Access Compliance Report

Public Rights-of-Way

Intersection ID: 11051	Main Street: E_21ST_ST	Cross Street: N_BREVARD_ST	Location: E
ADA ID: 511410669757	Ramp Type: PerpDiag	Initial Pass/Fail: Fail	Overall Compliance: No
Severity Score: 22.5			
Codes/Mitigation Info/Possible Solution		Field Measurements/Component Compliance

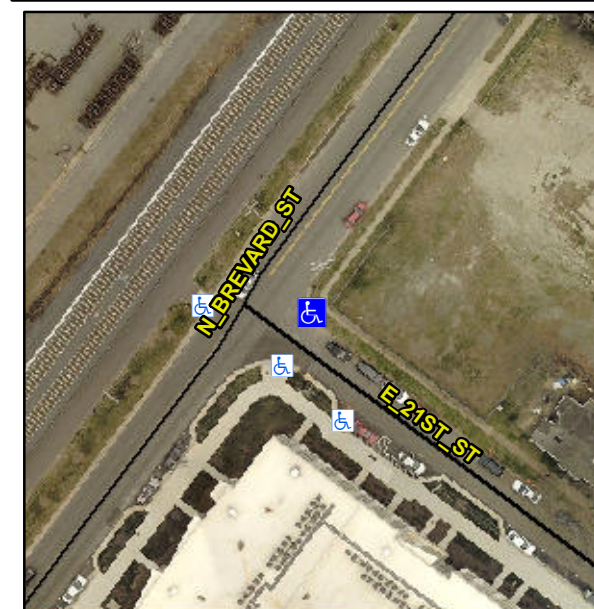
R304.5.1, R304.2.2, R304.5.3

Compliance	Description	Data	Compliance	Description	Data
N/A	Ramp Length (in)	53.0	No	Ramp Slope (%)	9.3
No	Ramp Width (in)	47.0	No	Ramp XSlope (%)	3.6
N/A	Flare Type LT	N/A	N/A	Flare Type RT	N/A
N/A	Flare Slope LT (%)	N/A	N/A	Flare Slope RT (%)	N/A
N/A	Flare Traversable LT?	N/A	N/A	Flare Traversable RT?	N/A
N/A	Landing Length (in)	N/A	N/A	DWS Provided?	N/A
N/A	Landing Width (in)	N/A	N/A	DWS Contrast?	N/A
N/A	Landing Slope (%)	N/A	N/A	DWS Length (in)	N/A
N/A	Landing X Slope (%)	N/A	N/A	DWS Full Width?	N/A
N/A	Landing Curb? (Y/N)	N/A	N/A	DWS Offset (in)	N/A
N/A	Shared Landing?	N/A			
N/A	Gutter Ponding?	N/A	N/A	Gutter Slope (%)	N/A
N/A	Gutter Lip Ht (in)	N/A	N/A	Gutter X Slope (%)	N/A
N/A	Painted X Walk1?	No	N/A	Painted X Walk2?	No
	X Walk 1 Direction	To NW		X Walk 2 Direction	To SW
N/A	X Walk 1 Width (in)	N/A	N/A	X Walk 2 Width (in)	N/A
	X Walk 1 Slope (%)	0.8		X Walk 2 Slope (%)	1.4
	X Walk 1 X Slope (%)	1.4		X Walk 2 X Slope (%)	0.3

Remove & Replace Curb Ramp With Two New Directional Ramps or Equivalent.
